Addendum No. 1
May 11, 2023

JSD Jefferson E.S.

Musgrove Engineering Mechanical Addendum #1 dated 5/11/23, (7) pages, with (36) revised and attached drawing sheets.

Musgrove Engineering Electrical Addendum #1 dated 5/11/23, (3) pages, with (6) revised and attached drawing sheets.

DATE: February 24, 2023
LKV PROJECT #: -
REVISIONS:
5/11/23
DRAWN BY: MS
CHECKED BY: WT
Agency Review
DRAWING NO.
A-2.3

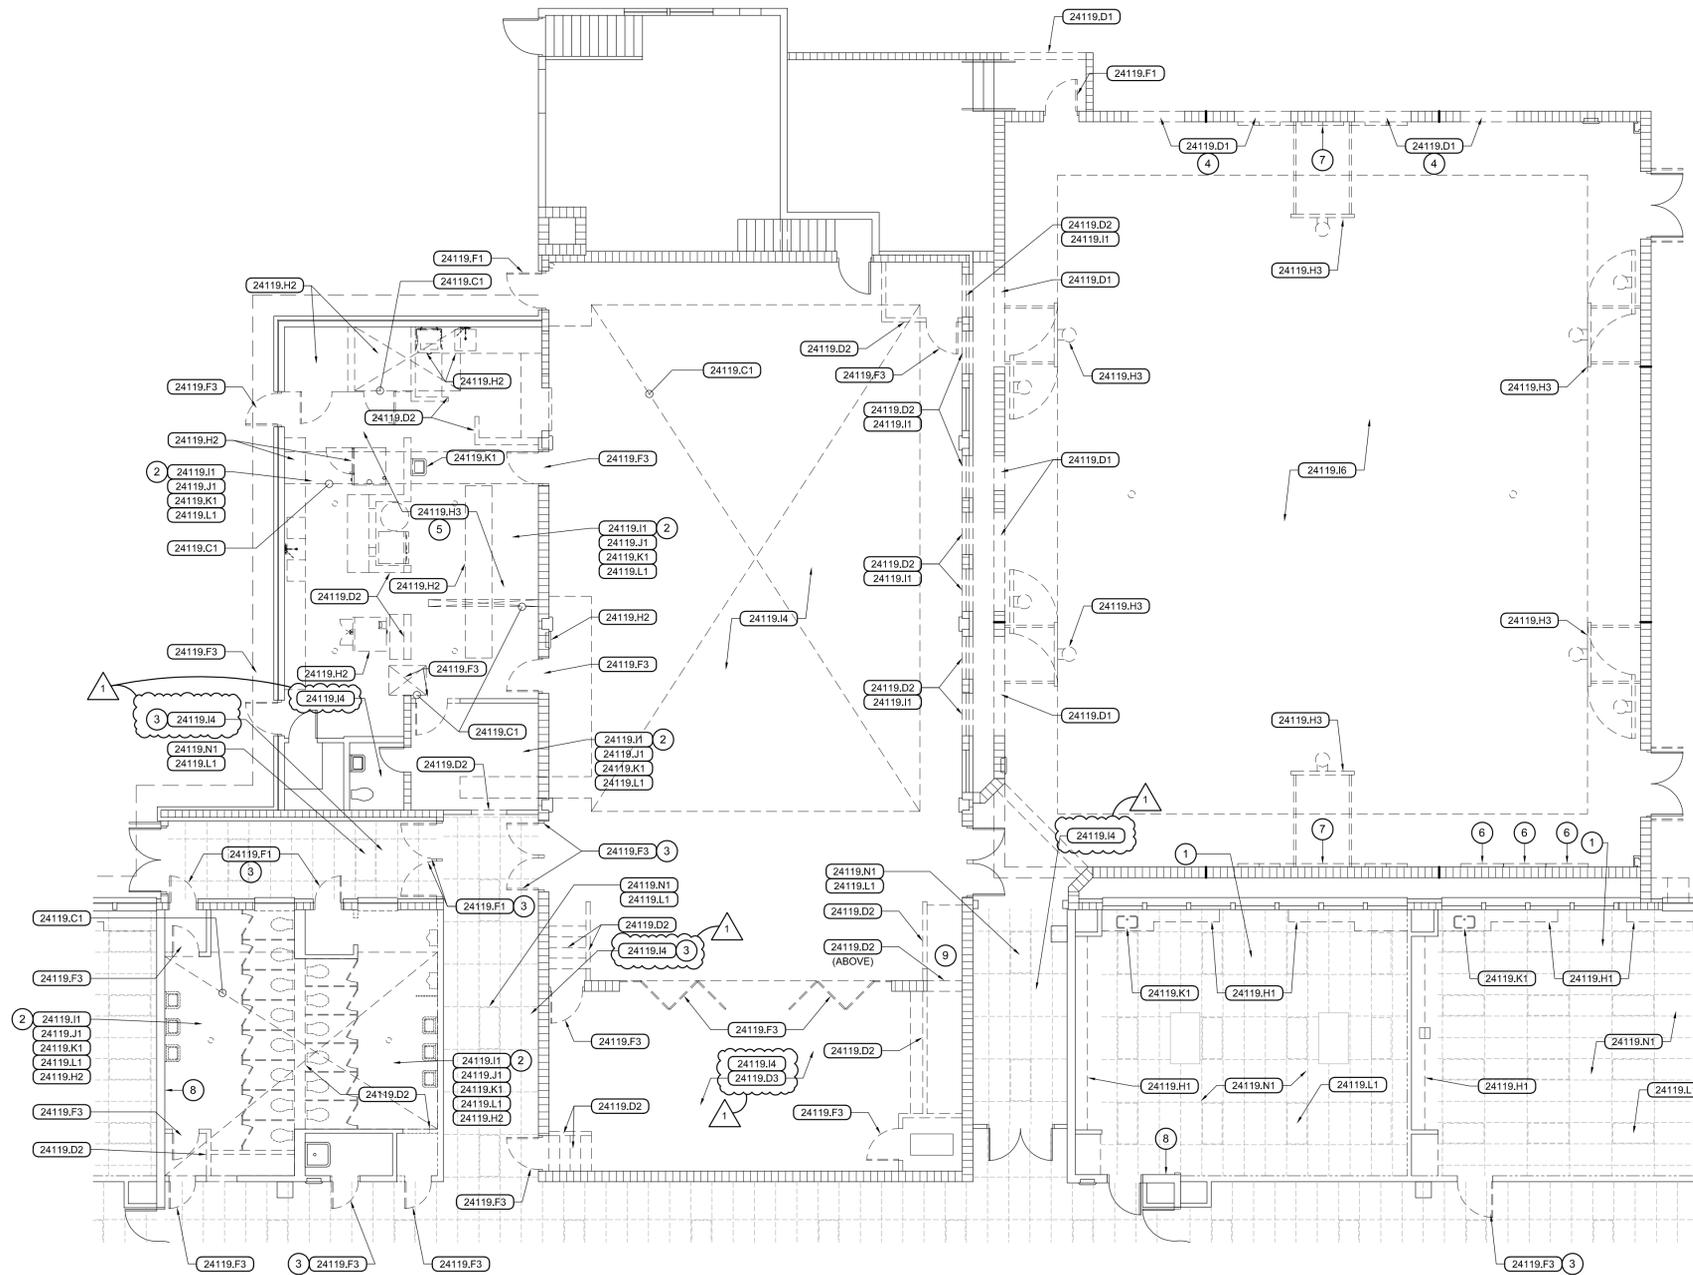
See revised Sheets A-2.2 – A-2.6 containing selective demolition clarifications related to existing flooring removal dated 2/11/23 attached to this Addendum.

Fire Protection Criteria Plan
 Scale: 1/16" = 1'-0"

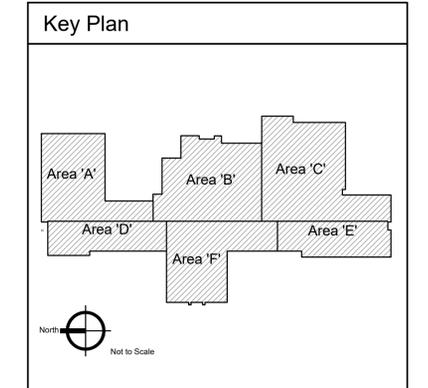
1. FDC was removed from the building and note M was added to indicate remote FDC is required. See the Sheet for further information.

- M. FDC SHALL BE REMOTE MOUNTED LOCATION SHALL BE APPROVED BY JEROME FIRE CODE OFFICIAL.

1 Mechanical Demolition Plan - Area 'A'
Scale: 1/8" = 1'-0"

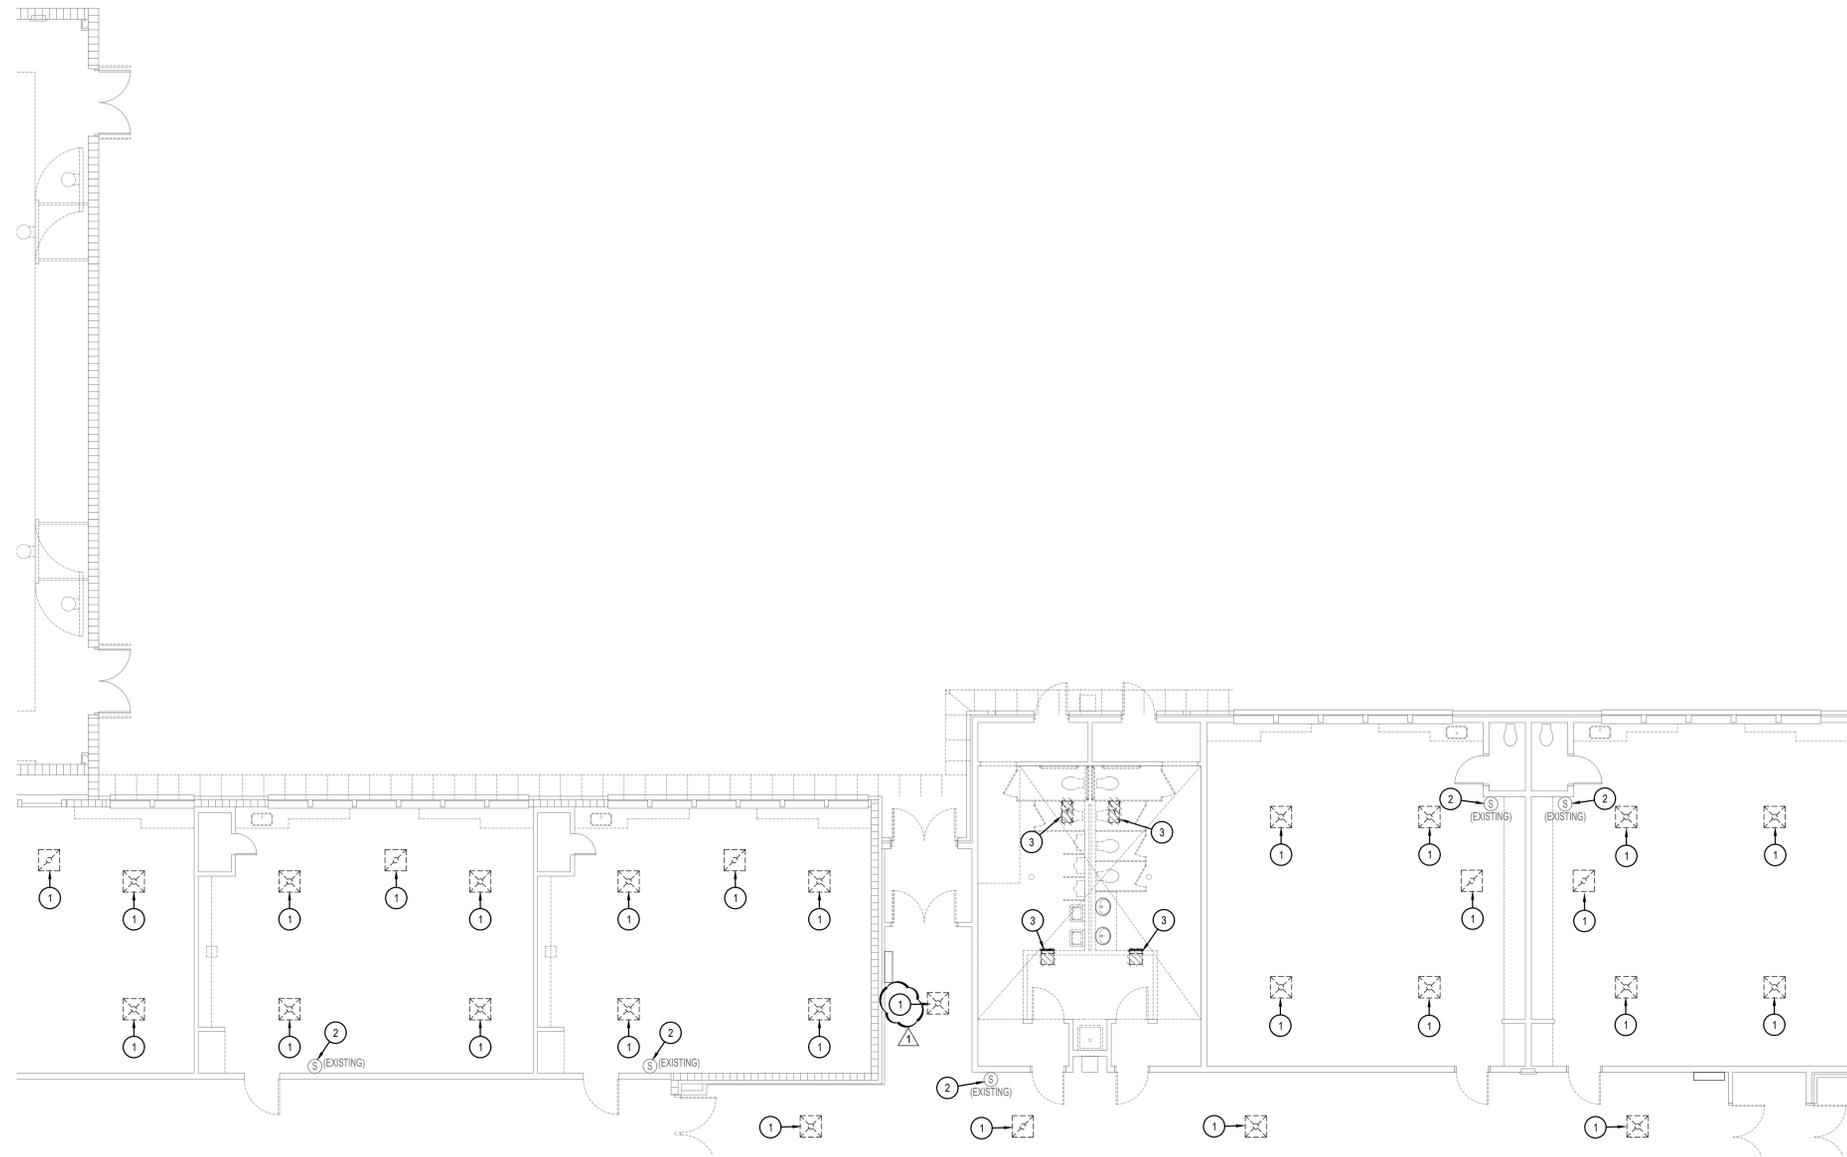
1. Added keynote 3, changed plan keynote for sensor. See the Sheet for further information.

M-1.3

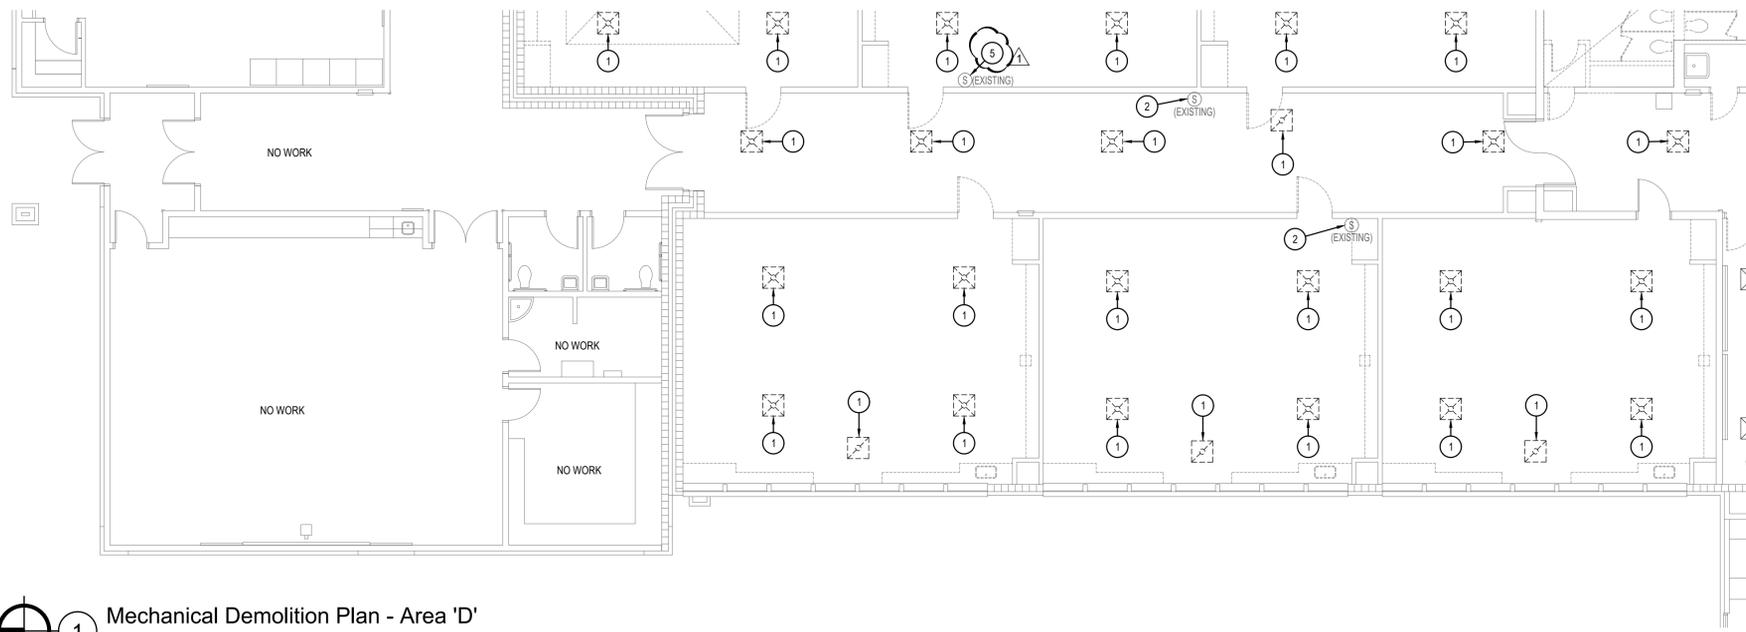
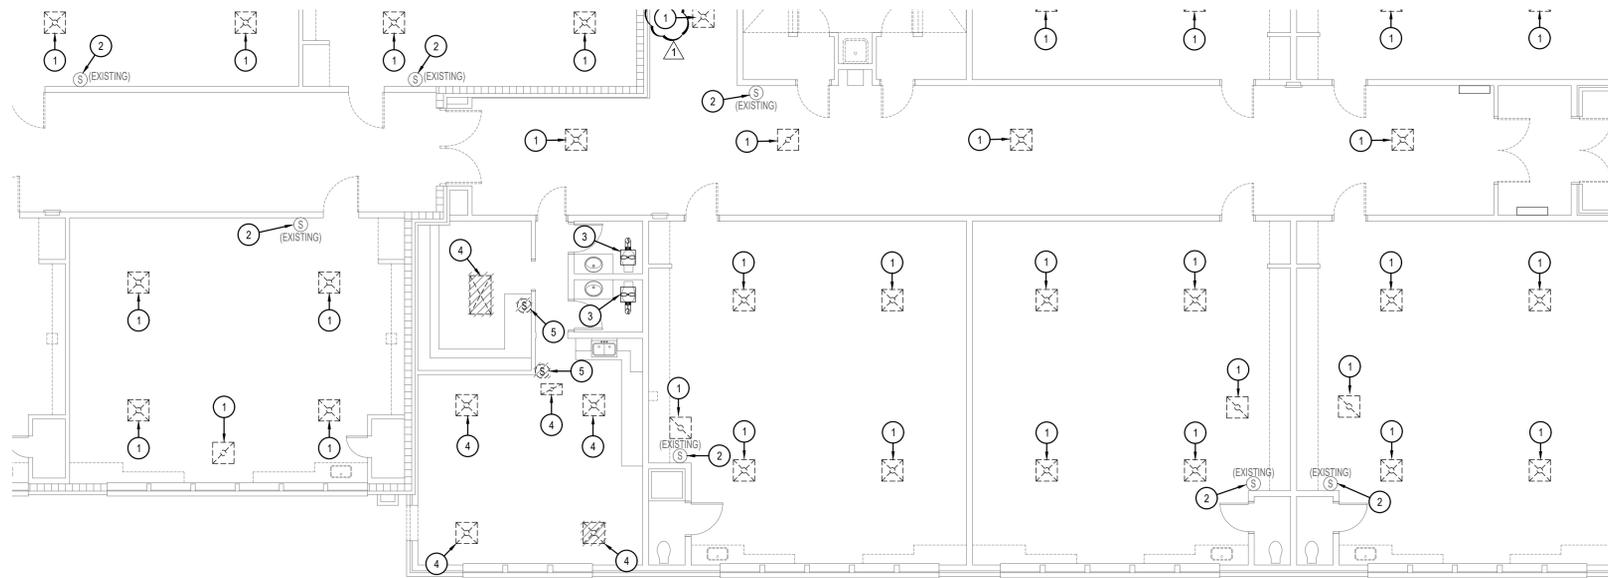
1. Corrected plan keynote. See the Sheet for further information.

1 Mechanical New Work Plan - Area 'A'
Scale: 1/8" = 1'-0"

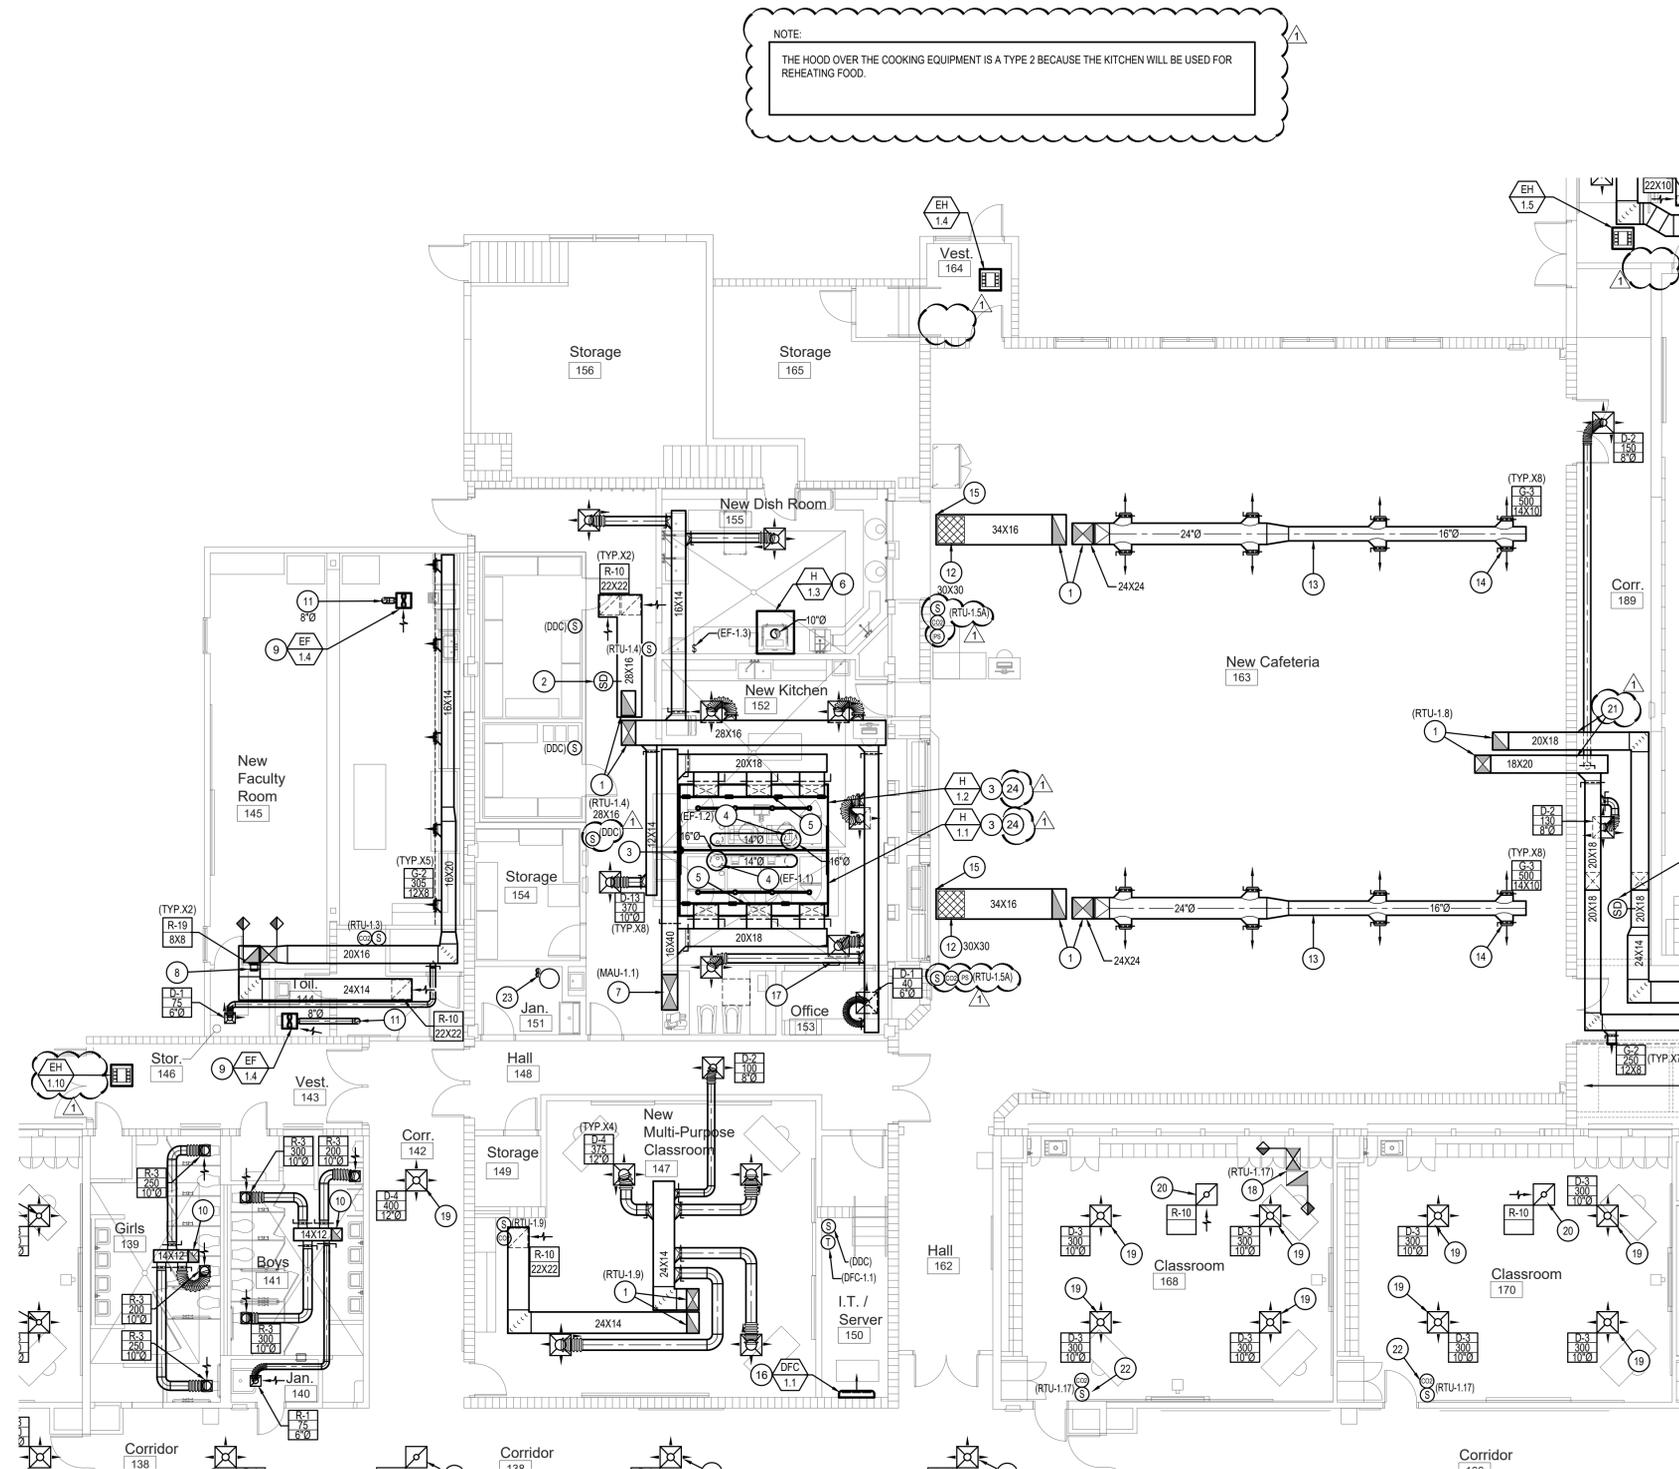
1. Changed grille callout in room 120.
2. Added averaging sensors.
3. Added bid alt#2 note.
4. Removed co2 sensor in hallway unit RTU-1.13.
See the Sheet for further information.

M-2.3

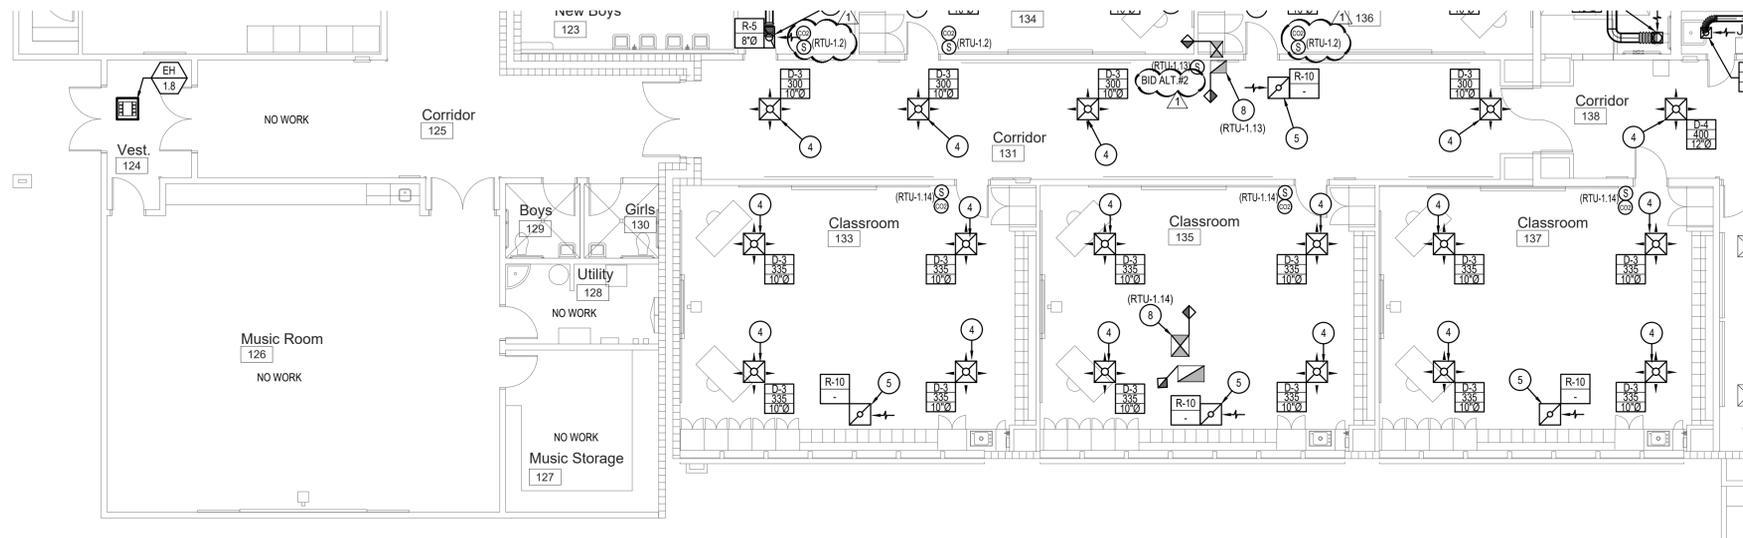
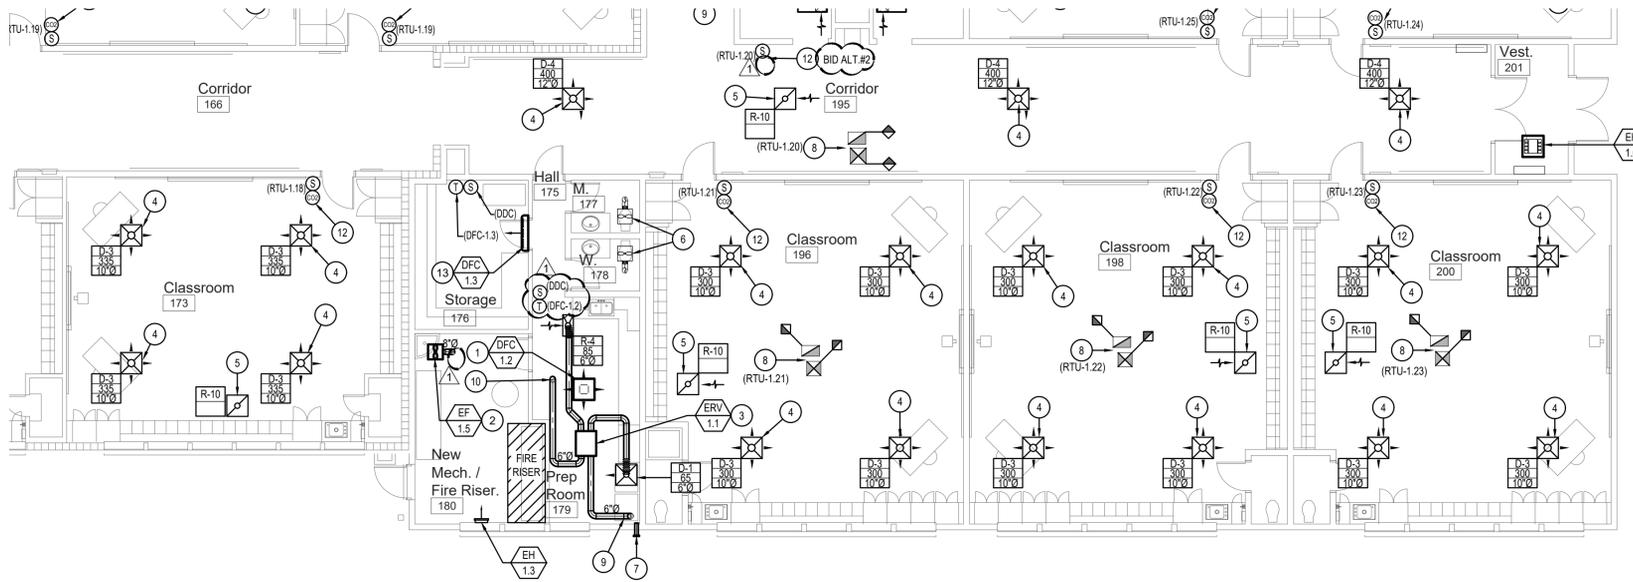
1. Added keynote 13 for smoke duct detector.
2. Added keynote 12 for Bid alternate note.
3. Added keynote 11 for destratification fan.
4. Added pressure sensor.

5. Added wall grilles R-21.
6. Added Sensor for destratification fan.
7. Corrected RTU wall callout to RTU-1.7a and RTU-1.7b
8. Removed Co2 Sensor corridor.
9. Removed remote thermostat for EH-1.5 & EH-1.1
See the Sheet for further information.
